Access Compliance Report

Public Rights-of-Way

(Curb Ramps)

Intersection ID: 2846	Main Street: BEITH_CT	Cross Street: TAYMOUTH_LN	Location: SE
ADA ID: D22301B41C6A	Ramp Type: PerpDiag	Initial Pass/Fail: Fail	Overall Compliance: No
Codes/Mitigation Info/Possible Solution			Severity Score: 50
			Field Measurements/Component Compliance

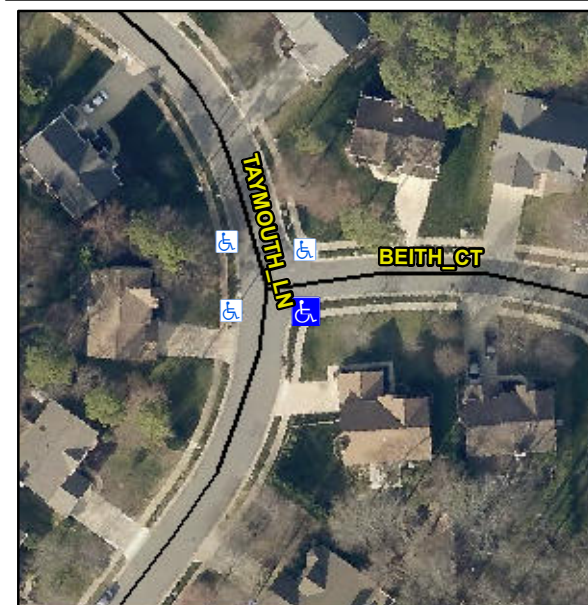
Not Found, R304.2.2, R304.5.3

Compliance	Description	Data	Compliance	Description	Data
N/A	Ramp Length (in)	47.0	No	Ramp Slope (%)	17.4
Yes	Ramp Width (in)	48.0	No	Ramp XSlope (%)	7.6
N/A	Flare Type LT	N/A	N/A	Flare Type RT	N/A
N/A	Flare Slope LT (%)	N/A	N/A	Flare Slope RT (%)	N/A
N/A	Flare Traversable LT?	N/A	N/A	Flare Traversable RT?	N/A
N/A	Landing Length (in)	N/A	N/A	DWS Provided?	N/A
N/A	Landing Width (in)	N/A	N/A	DWS Contrast?	N/A
N/A	Landing Slope (%)	N/A	N/A	DWS Length (in)	N/A
N/A	Landing X Slope (%)	N/A	N/A	DWS Full Width?	N/A
N/A	Landing Curb? (Y/N)	N/A	N/A	DWS Offset (in)	N/A
N/A	Shared Landing?	N/A			
N/A	Gutter Ponding?	N/A	N/A	Gutter Slope (%)	N/A
N/A	Gutter Lip Ht (in)	N/A	N/A	Gutter X Slope (%)	N/A
N/A	Painted X Walk1?	No	N/A	Painted X Walk2?	No
	X Walk 1 Direction	To N		X Walk 2 Direction	To W
N/A	X Walk 1 Width (in)	N/A	N/A	X Walk 2 Width (in)	N/A
	X Walk 1 Slope (%)	0.8		X Walk 2 Slope (%)	5.1
	X Walk 1 X Slope (%)	6.0		X Walk 2 X Slope (%)	0.5

Remove & Replace Curb Ramp With Two New Directional Ramps or Equivalent.
